UN Regulation No. 48 (Installation of Lighting and Light-Signalling Devices)

# Proposal for a Supplement to the 06, 07 and 08 series of amendments to UN Regulation No. 48

Submitted by the expert from the International Organization of Motor Vehicle Manufacturers\*

Picture **Examples of logos**

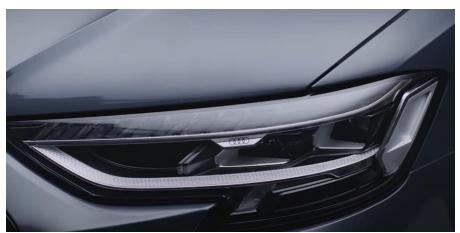
1. The definition of "manufacturer logo" excludes trademarks of the lamp or vehicle manufacturers that are present on the apparent surface of lamps for decades without any complaints to traffic safety. The introduction of the requirements on logos as a Supplement to existing UN Regulations means that component manufacturers are enforced to remove the trademarks/logos from their designs as soon as amendments to their approvals become necessary, or as soon as they apply for approvals pursuant to UN Regulation No. 148 for lamps approved to the previous UN Regulations, e.g. No. 7. This introduces costs for the modification of production tools without any benefit to traffic safety.

- 2. As the current text of the 01 series of amendments to UN Regulation No. 148 and the associated amendments to UN Regulation No. 48 only allow official logos/trademarks, such inscriptions or graphics will be forbidden in the future. This proposal intends to allow those graphics in a very limited way in addition to the official manufacturer logos.
